Pentium® Processor Specification Update

Release Date: October 1997

Order Number: 242480-031

The Pentium® processor may contain design defects or errors known as errata which may cause the product to deviate from published specifications. Current characterized errata are documented in this Specification Update.

1. ***Pentium® Processor's Response to Startup and Init IPIs***

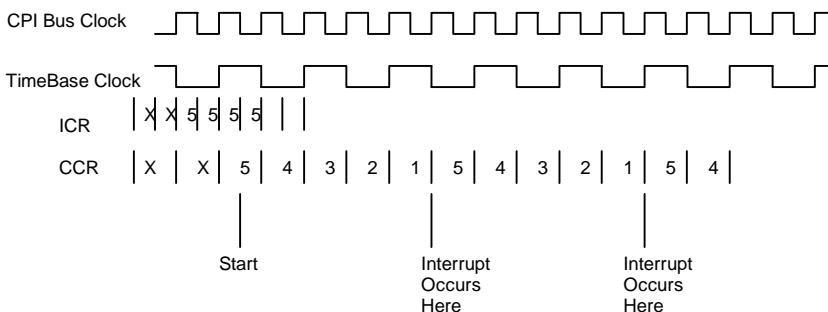
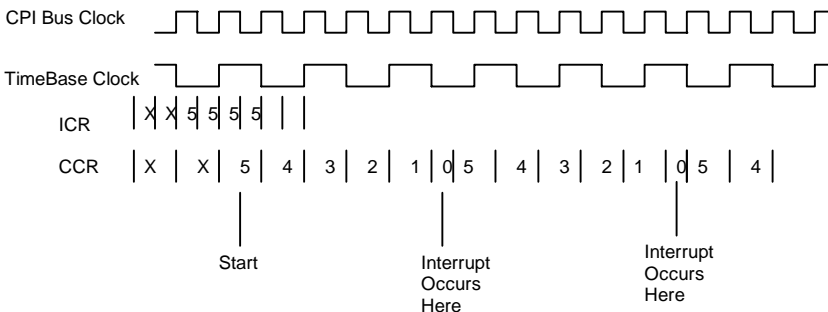
```
BSP sends AP an INIT IPI
BSP DELAYS (10mSec)
If (APIC VERSION is not an 82489DX)
{
    BSP sends AP a STARTUP IPI
    BSP DELAYS (200uSec)
    BSP sends AP a STARTUP IPI
    BSP DELAYS (200uSec)
}
BSP verifies synchronization with executing AP
```

For additional information please refer to the *Intel Multiprocessor Specification*, Version 1.4 (Order Number 242016).

2. **Incorrect TCP Pinout Drawing**

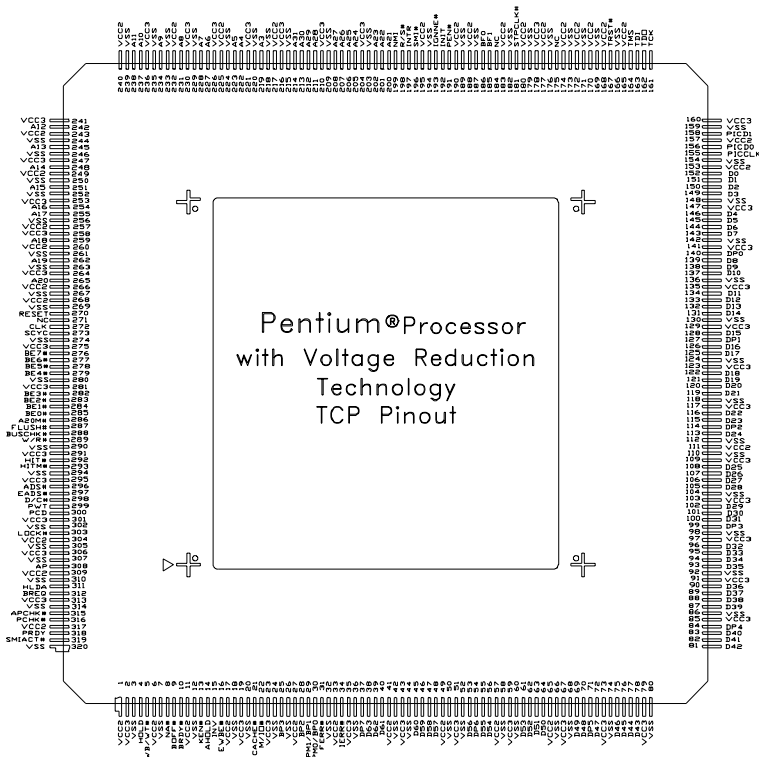
The TCP pinout drawing on page 8 of the *Pentium Processor with Voltage Reduction Technology* datasheet was inadvertently rotated. The correct orientation is shown below.

Figure 14-1. Maximum Undershoot Level, Undershoot Threshold Level, and Undershoot Threshold Duration

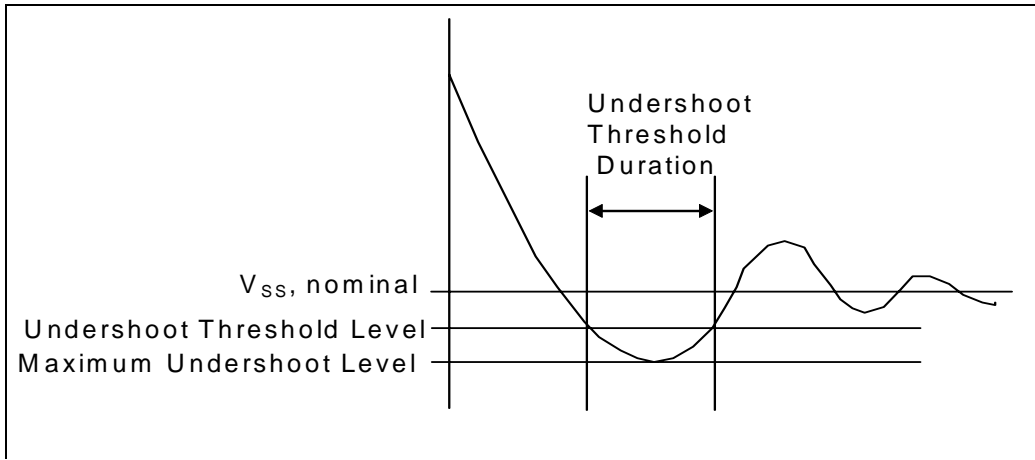
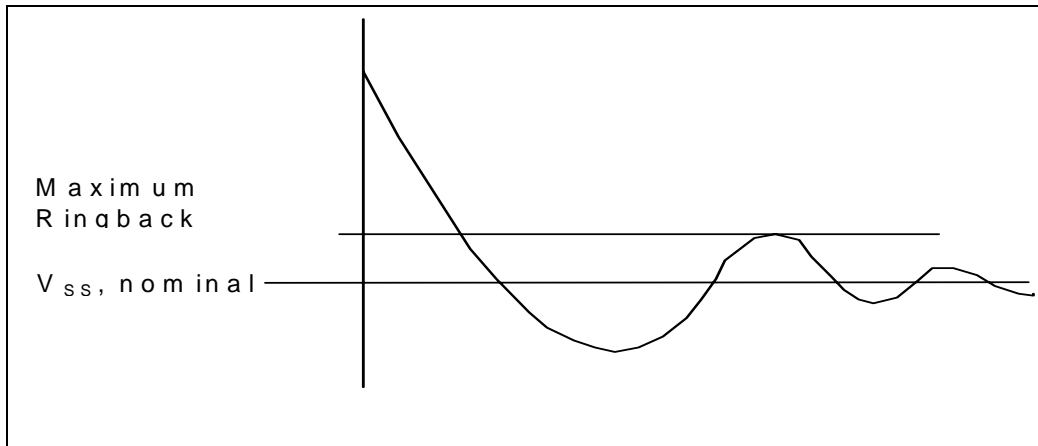
MAXIMUM RINGBACK SPECIFICATION: The maximum ringback of CLK associated with its low state (undershoot) must not exceed 0.8V as shown in Figure 14-1.

MAXIMUM UNDERSHOOT AND MAXIMUM RINGBACK SPECIFICATIONS: The display should show continuous sampling (e.g., infinite persistence) of the waveform at 500 mV/div and 5 ns/div (for CLK) for a recommended duration of approximately five seconds. Adjust the vertical position to measure the maximum undershoot and associated ringback. There is no allowance for crossing the maximum undershoot or maximum ringback specifications.

UNDERSHOOT THRESHOLD DURATION SPECIFICATION: A snapshot of the clock signal should be taken at 500 mV/div and 500 pS/div (for CLK). Adjust the vertical position and horizontal offset position to view the threshold duration. The undershoot threshold duration is defined as the sum of all time during which the clock signal is below -0.5V within a single clock period. The undershoot threshold duration must not exceed 20% of the period.

This undershoot specifications are illustrated graphically in Figure 14-1 and Figure 14-2.
